Application number(s):		22/01528/LB and 22/01527/F			
Application site:		14 & 15 High Street, Banbury, Oxfordshire OX16 5EE			
Proposal:		Conversion of upper floors to 3 apartments. New access in front facade			
X	Listed Building	Х	Conservation Area		Setting of a Listed Building
	Grade I		Grade II*	Х	Grade II
Policies	-		-		•
Cherwel	l Local Plan 2011-2031: Ado	pted Do	cument (July 2015) (As a	amended)	
Policy ESD15 New development proposals should: Conserve, sustain and enhance designated and non-designated 'heritage assets' including buildings, features, archaeology, conservation areas and their settings, and ensure new development is sensitively sited and integrated, furthermore development should respect the traditional pattern of the form, scale and massing of buildings					
Cherwel	l Local Plan 1996 Saved Poli	cies			
х	C18 in determining an application for listed building consent the council will have special regard to the desirability of preserving the building or its setting or any features of special architectural or historic interest. The council will normally only approve internal and external alterations or extensions to a listed building which are minor and sympatheti

### Looking from No 14 towards No15 at first floor:

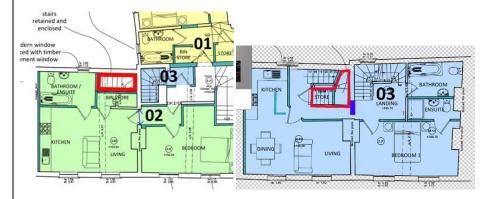
Oddly, the existing plan shows 1st floor levels at both Nos 14 and 15 as +103.24. Is there any evidence that the two buildings were ever linked at 1<sup>st</sup> floor, or is the coincidence due to them being a contemporary build?

There would appear to be scope to have an opening between the two properties but we should ask to see the existing and proposed lintel and opening, relative to the existing stair walls and the chimney flues, looking from No 14 and from No 15.

Fig 4 from the D&A Statement shows a traditional shopfront with transom.

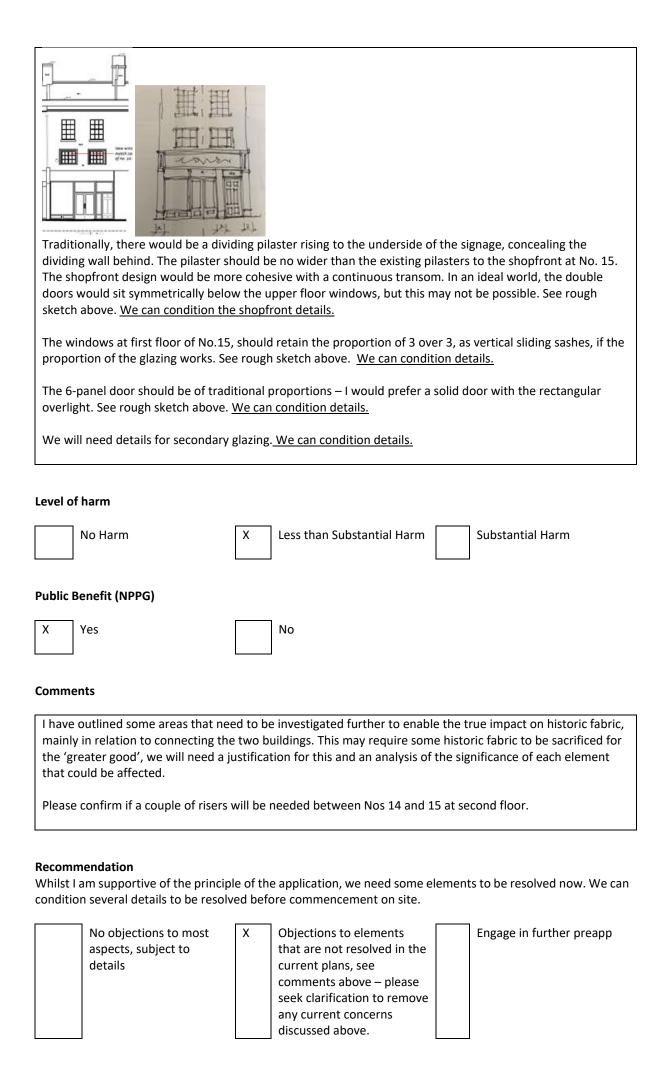
The proposed elevation shows the height of the signage reduced, and we would normally support this, however, the 'capitals' should relate to the depth of the signage, and it would look very odd to retain the taller 'capitals' with a shortened fascia signage. If the signage is reduced the capitals would need to also reduce so that the top aligned.
